ANSEMI ACRES SUBDIVISION

PART OF THE SOUTHWEST QUARTER OF SECTION 21, TOWNSHIP 6 NORTH, RANGE 2 WEST, SALT LAKE BASE & MERIDIAN, U.S. SURVEY
WEBER COUNTY, UTAH
MAY, 2023

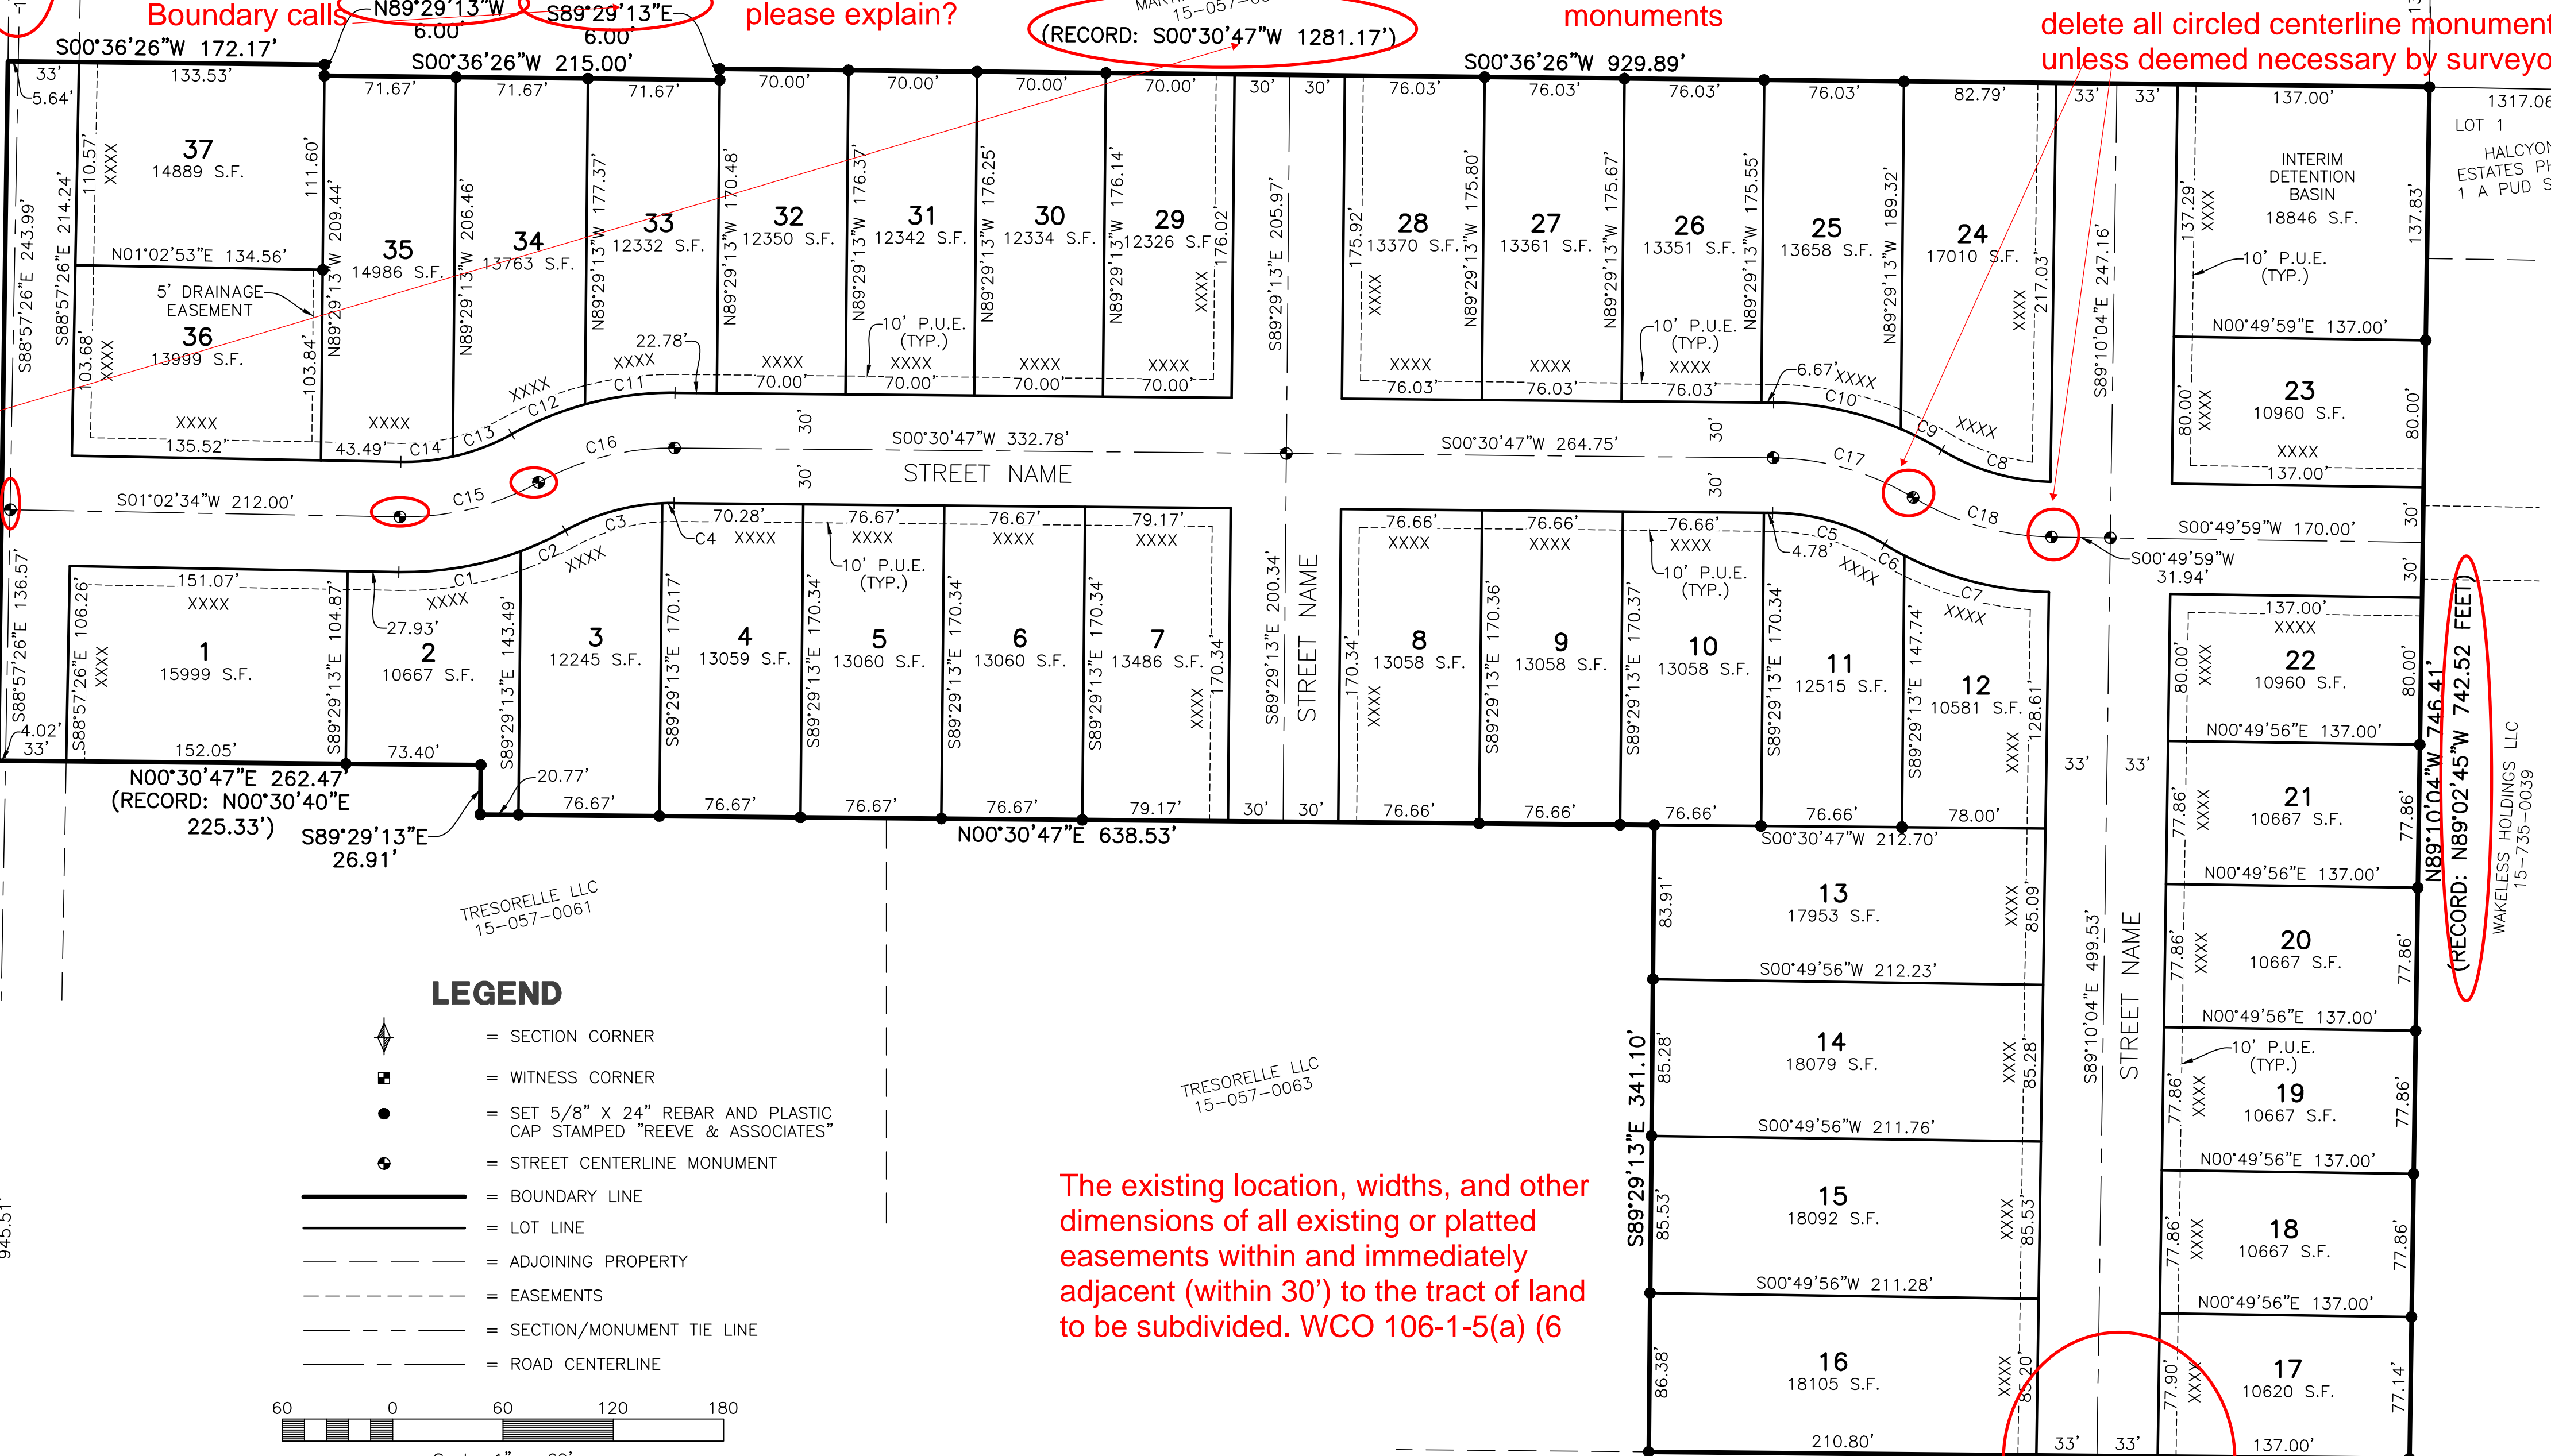
does not match annex plat 94-072 explain

The existing location, widths, and other dimensions of all existing or platted fence lines or other lines of occupation within or immediately adjacent to the tract to be subdivided. WCO 106-1-5(a)(6)

Need to show found evidence of occupation "ie fences, buildings, walls, ditches etc." for the east and North boundary for the 6' jog and 6' difference from record across North and South Boundary" what deed or document did record come from?

The existing location, widths, and other dimensions of all existing or platted streets or railroad lines within and immediately adjacent (within 30') to the tract of land to be subdivided. WCO 106-1-5(a)(6)

The existing location, widths, and other dimensions of all existing or platted land drains, culverts, watercourses, wetlands, streams corridor setbacks, flood plain within and immediately adjacent (within 30') to the tract of land to be subdivided. WCO 106-1-5(a)(6)

Location of ditches within and along boundary

Permanent street monuments shall be accurately set at points necessary to establish all lines of the street. Centerline monuments shall be noted on the final plat. WCO 106-4-2(g) & WCO 106-1-8(c)(1) Subdivision Monument letter will be done on next review for all centerline monuments

delete all circled centerline monuments unless deemed necessary by surveyor

The existing location, widths, and other dimensions of all existing or platted easements within and immediately adjacent (within 30') to the tract of land to be subdivided. WCO 106-1-5(a)(6)

is a temporary turn around needed for emergency vehicles
